July 1, 2005

Point Beach Nuclear Plant, Unit 1
Docket 50-266
License No. DPR-24

Reactor Vessel Closure Head Penetration Flaw Characterization Relief Request
MR 02-018-2, Revision 2

Relief Request No. MR 02-018-2, Revision 2, Characterization of Remaining Flaws – Reactor Vessel Closure Head Penetrations

Figure 1

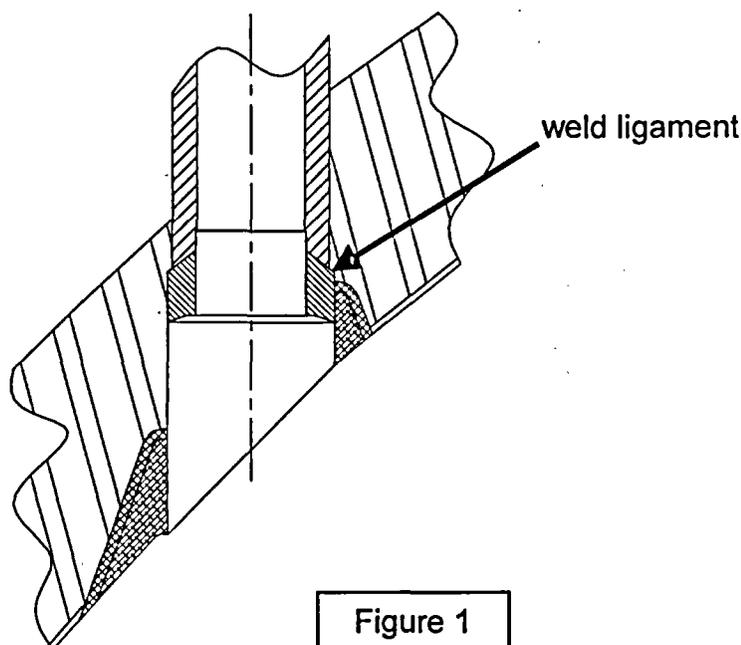
The evaluation of the repair of Unit 1 RVCH penetration #26 included measurement of the Alloy 52 to Alloy 82/182 overlap and weld ligament dimensions. The weld ligament was found to be 0.5-inch. The weld ligament is defined as the portion of the new Alloy 52 pressure boundary weld that is not overlapping with the original J-groove weld (Alloy 82/182). Refer to Figure 1 below.

This measurement was performed to support analysis of a worst-case flaw in the existing Alloy 82/182 material that grows through the Heat Affected Zone (HAZ) of the new Alloy 52 pressure boundary weld. Although not detected in the post-welding NDE processes, the analysis also conservatively assumed the existence of a 0.1-inch root defect in the new Alloy 52 pressure boundary weld. This assumption reduces the assumed weld ligament from 0.5-inch to 0.4-inch.

Calculations using Alloy 82/182 crack growth rates contained in Structural Integrity Associates (SIA) calculation PBCH-09Q-302, Revision 2, showed that it would take 1.39 EFPY for a flaw located at the weld/head interface to propagate through the Alloy 52 weld, using a RVCH temperature of 592°F. Crack growth rates in Alloy 52 material are very low. Reference 2 concluded that use of the Alloy 82/182 crack growth rate is a conservative representation for Alloy 52, since published information indicates that the crack growth rates are five to six times higher in Alloy 82 welds than in Alloy 600 nozzle materials.

A summary (Enclosure 2) of the recently revised analysis of the upper head fluid conditions has determined that the temperature is slightly higher at 593.9°F vice 592°F. Calculations show that it would take 1.31 EFPY, for a flaw located at the weld/head interface, to propagate through the Alloy 52 weld using the updated RVCH temperature of 593.9°F. This analysis conservatively used Alloy 82/182 crack growth rates and included an assumed 0.1-inch root defect. This PWSCC repair life analysis is contained in SIA calculation PBCH-09Q-302, Revision 3, provided in Enclosure 3.
